Sygensys FRCR 2025 Consultation Response

Sygensys
7th April 2025

FRCR 2025 feedback

Figure 30 Annual number of minutes outside the standard ranges in Great Britain for 2019–2023

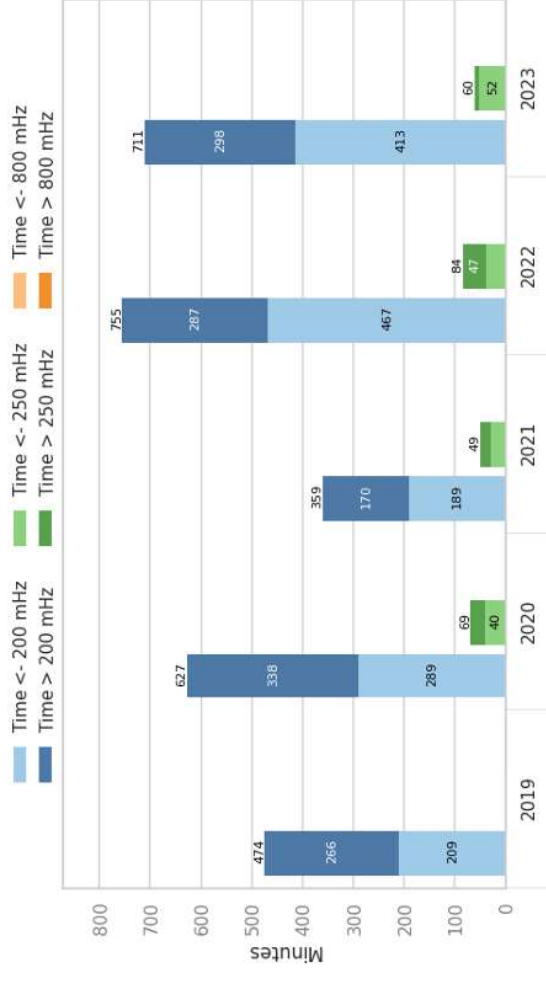
- Consider better reporting of trends vs time in future versions of FRCR
- For example see [ENTSO-e 2023 ALFC Report](#)
